UNITED STATES PATENT AND TRADEMARK OFFICE

APPLICATION NO.	FILING DATE	FIRST NAMED INVENTOR	ATTORNEY DOCKET NO.	CONFIRMATION NO.
10/643,543	08/19/2003	Georg Wall	HBC 251-KFM 17657-US	4260

Office Action Summary

DETAILED ACTION

3,302,412

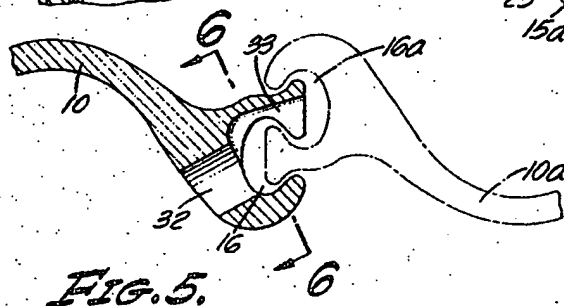
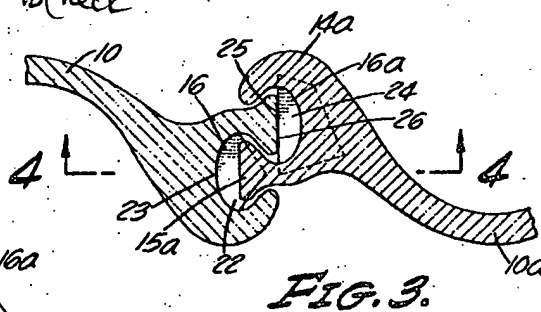
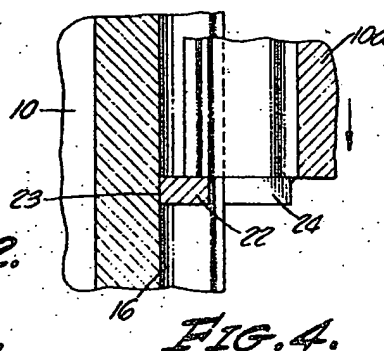
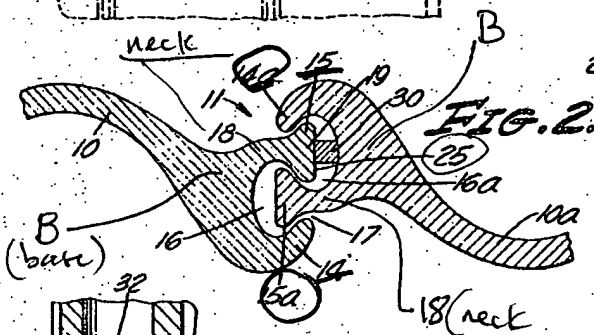
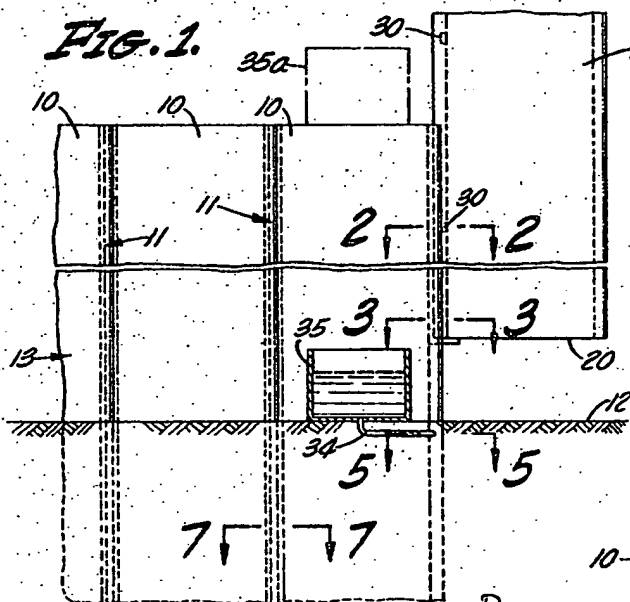
In regard claim 1, Hunsucker teaches interlocking sheet piles and method of installation comprising two interlocking strip shaped joining elements 10, 10a. Each of the joining elements comprising a neck strip 18 projecting away from a base B (see attachment of figure 2), an adjoining button strip 14 and the second joining element 15

and the being affixable with a base B and comprises two hook strips 25 projecting away from the base B and encompass the button strip 14 of the first joining element inserted into hollow space 16a so that it is held in the hollow space 16a, characterized in that the base B of the first joining element comprises on its two longitudinal sides, the two hook strips serve as holding portions projecting away from the base which embrace outer sides of the hook strips of the second joining element. Since Hunsucker teaches the similar structures as the applicant's claimed invention, it's inherently capable of performing the same function such as preventing a widening of the hook strips in the case of tensile forces between the two individual elements.
